Town of Rutland

Traffic Safety and Field Recommendations

May 29, 2024

STATE OF WISCONSIN  
WISCONSIN DEPARTMENT OF TRANSPORTATION  
TOWN PLAT RECORD

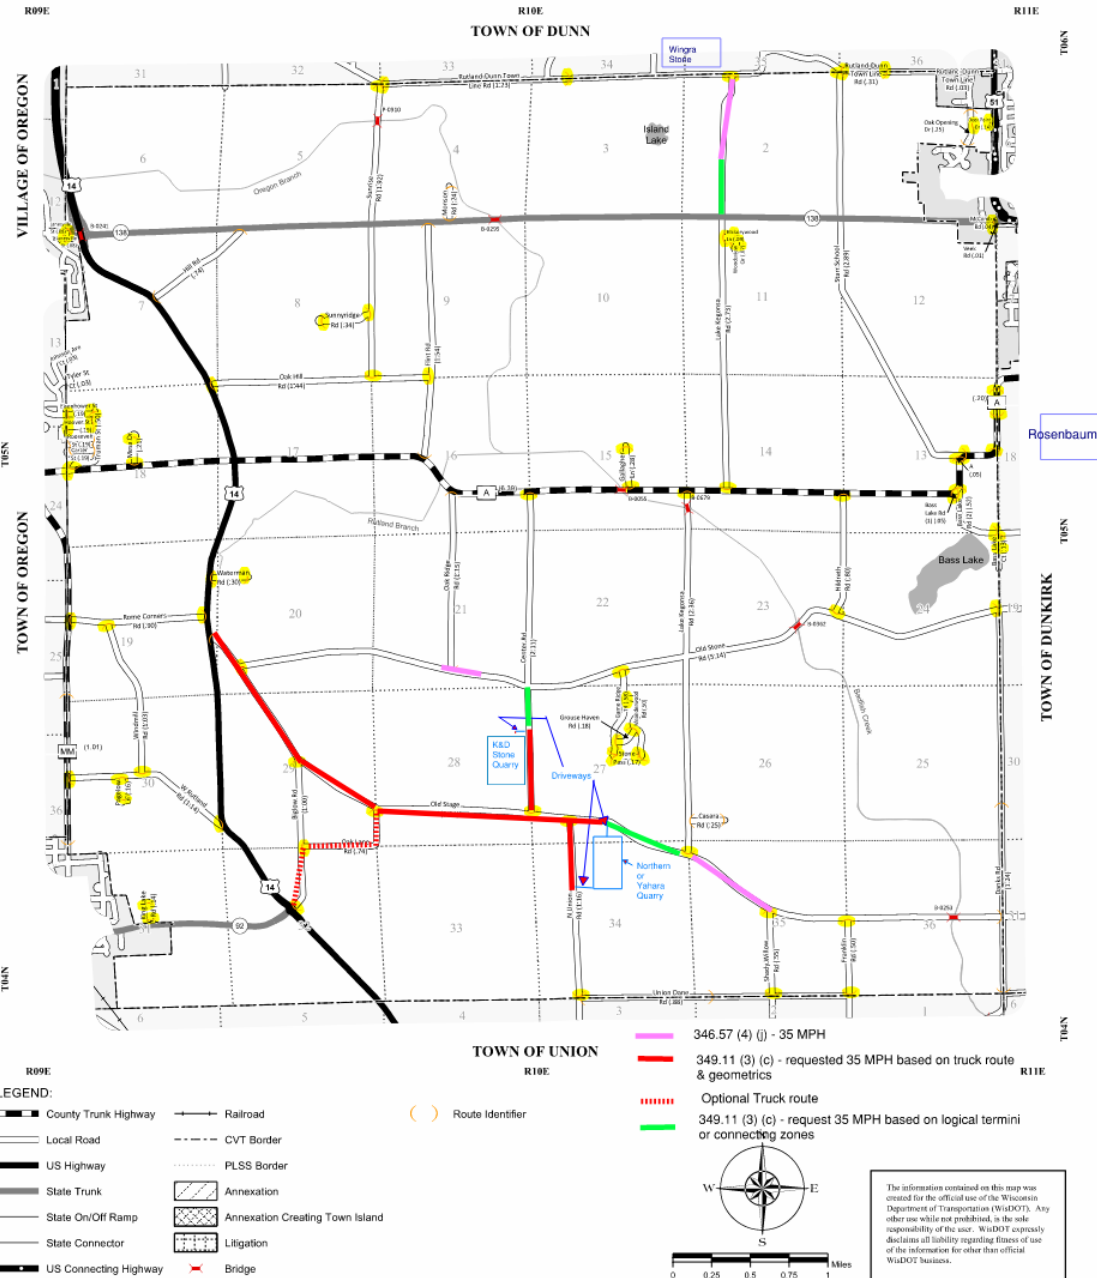
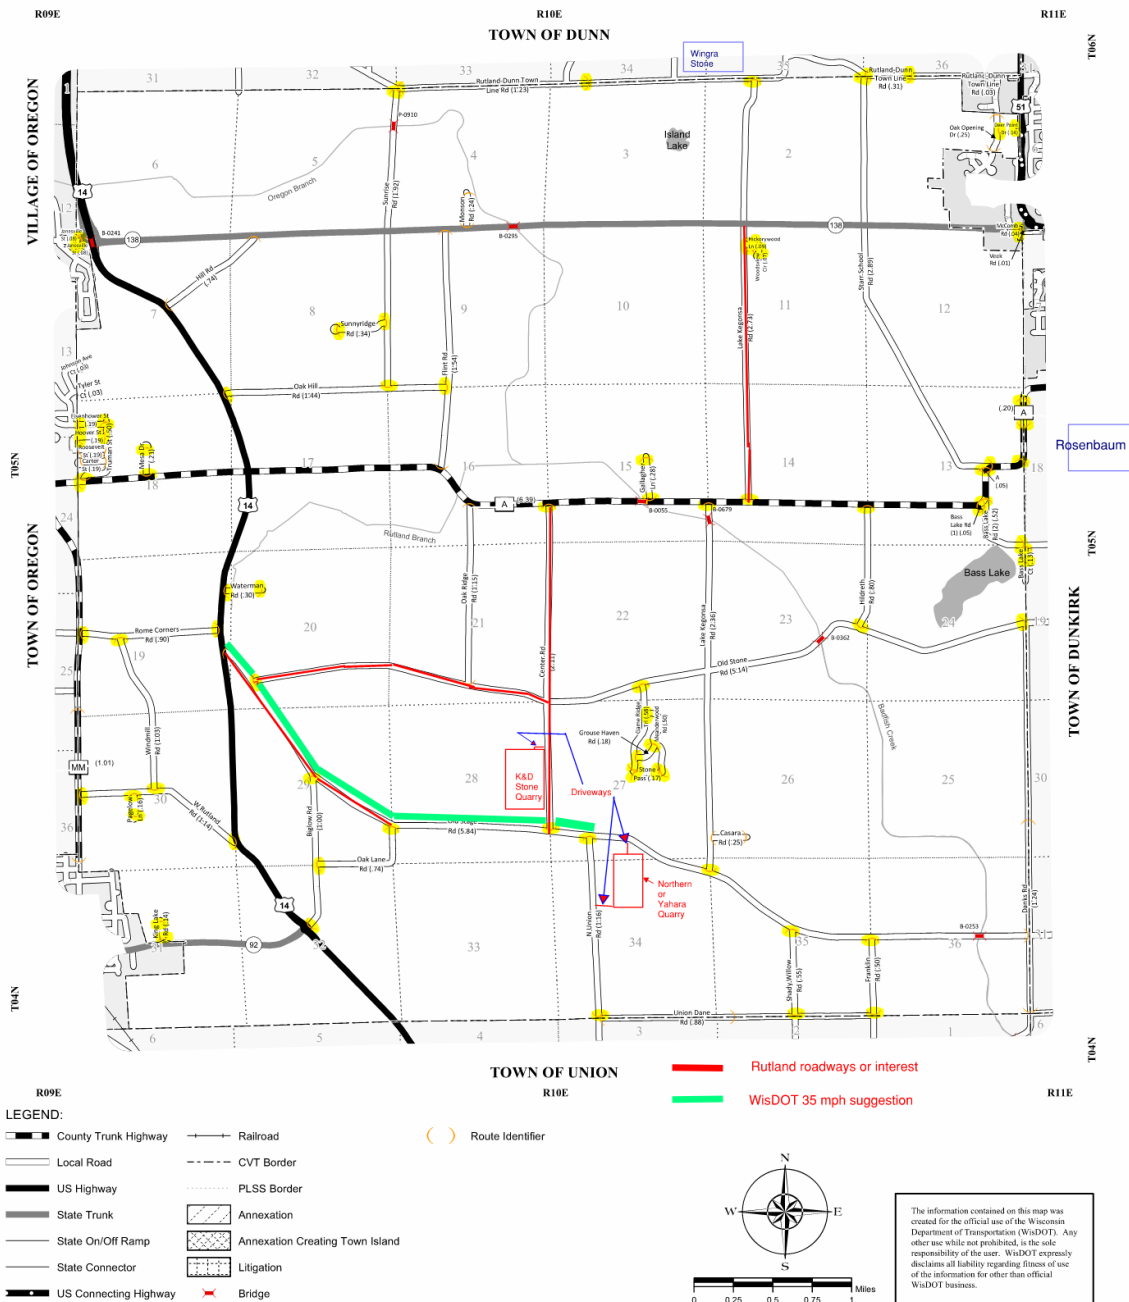
The Town of Rutland has two large quarries and the number of trucks driving through is very high. On the main truck route there are a few geometric features that are not ideal. It is suggested the Town work with the quarries to establish truck routes in and out of the township. The suggested routes are shown in red on the attached map, however, primarily occur on Old Stage Road. It appeared during the field visit that this was already the preferred route in use. It should also be noted that there is a potentially safer intersection for the trucks to enter or exit US 14 at the roundabout at Biglow Road and Wis 92. The intersection of Old Stage Road and US 14 is a stopped controlled intersection. US 14 also does not have a passing lane for turning trucks. The optional route has fewer houses on Oak Lane and Biglow roads, but they do have more turns on the Town roads. There is also an option for trucks only entering at one intersection and exiting at the other which would avoid two-way truck traffic on the worst segment of Old Stage Road.

This segment seems to be the most used route for trucks hauling from the quarries. There are some blind horizontal and vertical curves on this roadway along with multiple driveways.

Recommend that this segment be reduced to 35 mph. This speed zone could be stretched to the Yahara quarry entrance just east of N Union Rd if necessary.

The driveway entrance to the K&D stone quarry has sight distance less than 45 mph for parts of this segment. Signage could be installed for blind curves or hidden driveways.

Recommended to lower the speed limit on this segment of Center Rd to 35 mph, because of the quarry entrance with numerous trucks entering and leaving the site

This segment has an existing density of homes and driveways just east of Center Road with a posted 35 MPH based on 346.57 (4) (j). It appears that this zone could be extended west to Old Ridge Road. The rest of Old Stage Road does not meet 346.57 (4) (j) and does not have any additional features to justify a lower of the zone to 35. Truck routes should follow other roadway segments.

This segment of road does not meet 346.57 (4) (j) and does not have any additional features to justify a lower of the zone to 35. Truck routes should follow other roadway segments.

This segment of road does not meet 346.57 (4) (j) and does not have any additional features to justify a lower of the zone to 35. Truck routes should follow other roadway segments.

The team did however find a short segment of Lake Kegonsa Road north of WIS 138 that does meet 346.57 (4) (j). This is a short segment that would be logical to extend to bring the zone to logical termini which means this segment of Lake Kegonsa Road be lowered to 35 mph between WIS 138 and Rutland Town Line Road.
